MC/CTRB/Defects

Sub: En-route detachment of LHB Coach No. SER 182374 LWSCN from Train No. 12860 due to hot axle at BSL Railway Station of Central Railway on 07.02.2019.

Joint Inspection Note

Findings:

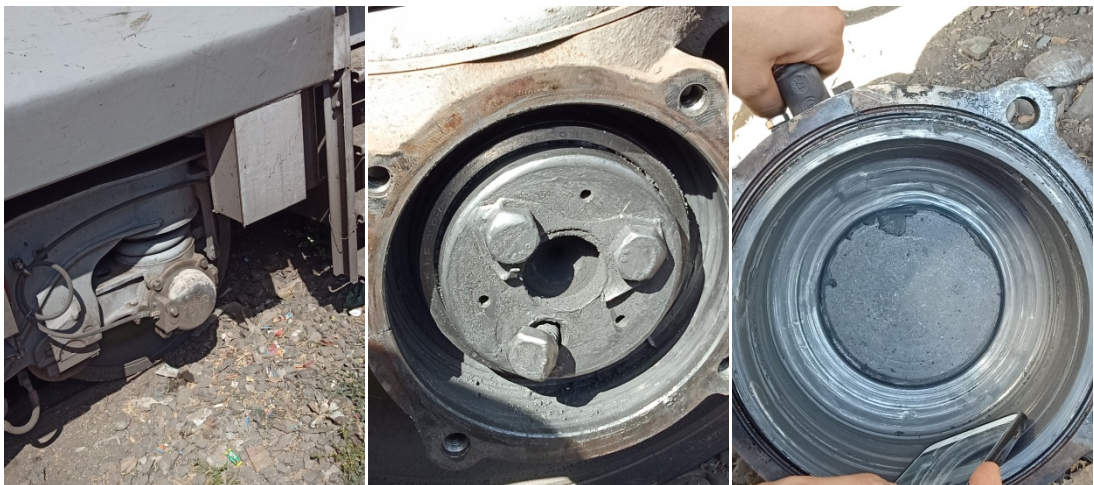
1. The axle end cover of reported axle box no. 2 (phonic wheel end) was opened for inspection. Phonic wheel was found damaged and broken into pieces and the teeth of phonic wheel had worn out.

2. Speed sensor was not found inside the axle box as the speed sensor had completely damaged and melted due to rubbing with phonic wheel and M8 bolts.
3. The all M8 bolts were found in worn out and damaged condition. Out of 03 M8 bolts, head of one bolt was not found inside the axle box. Remaining 02 M8 bolts & half M8 bolt were found in rubbed & damaged condition inside the axle box.

4. Heads of all M20 screws were deformed/worn. One M20 screw was bent & partially unscrewed.

5. Part of locking plate was damaged and missing at partially unscrewed M20 screw position. Remaining locking plate at rest of 02 M20 screw positions was found intact but in rubbed condition.

6. Rubbing marks & grooving were found at inside surface of the axle end cover.
7. The outboard side grease seal of the bearing was found in damaged condition.

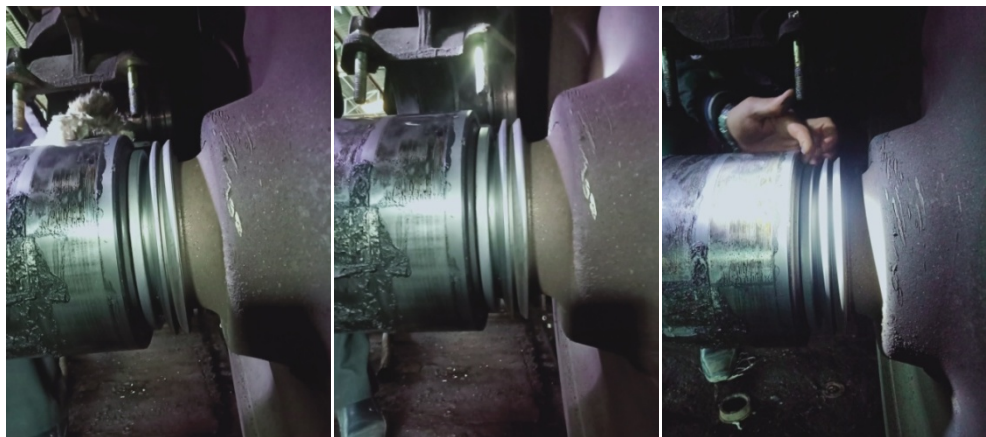
8. The coach was lifted in Sick Line. Outboard side grease (front side) seal of the reported bearing serial no. 06-18-13487 was found damaged and rubber lip had melted and deformed. Rubbing marks were observed on the out board side grease seal.
9. The inboard side grease seal and backing ring were found ok and intact. No damage found on the inboard side grease seal and backing ring of the reported bearing.

10. Bearing OD surface was found in good condition and no heating mark was found on the bearing OD surface.
11. The reported bearing was rotating freely onto the axle journal during hand rotation and no abnormal noise was observed during rotation of bearing.
12. Some amount of grease was found on the reported bearing Cup OD surface at outboard side and on the bore of the control arms (lower and upper half).

13. Rubbing marks were observed inside the upper & lower control arm towards outboard side only.
